May 21, 2013

**Re: Sunset Lake RV Park (00933) Secondary Treatment
Conditional Approval – PR# 199-2011**

Model for injection of general chemicals

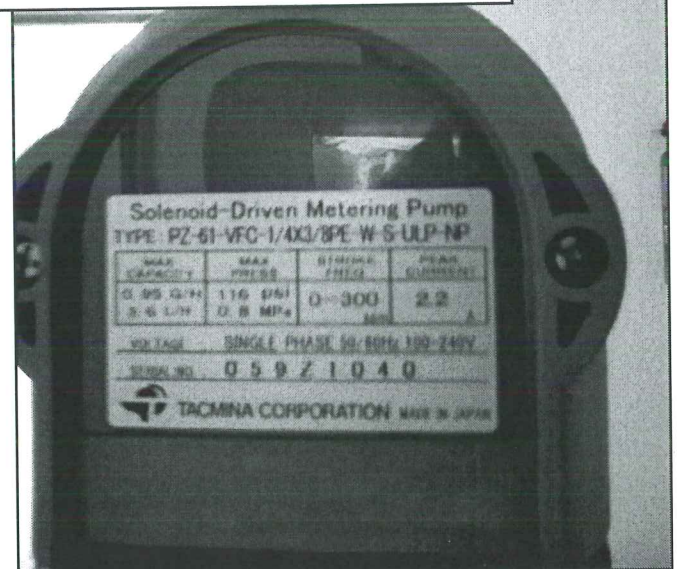
I was unable to find any documentation that indicated if the Neptune chlorine injection pump met NSF-61. Furthermore, the chlorine injection pump is described by the manufacturer's model code description as a "model for injection of general chemicals" and not the "model for injection of sodium hypochlorite" that this manufacturer provides (see model code descriptions on the following two pages).

Having received further documentation regarding the treatment system for the Sunset Lake RV Park, collected at the time of the last water system survey conducted by Maureen Taylor on September 20, 2012 and a review of the equipment installed, **the system will not be granted Final Plan Approval until the chlorine injection pump is replaced with one that meets National Sanitation Foundation Standard 61 (NSF-61).** The treatment system currently consists of:
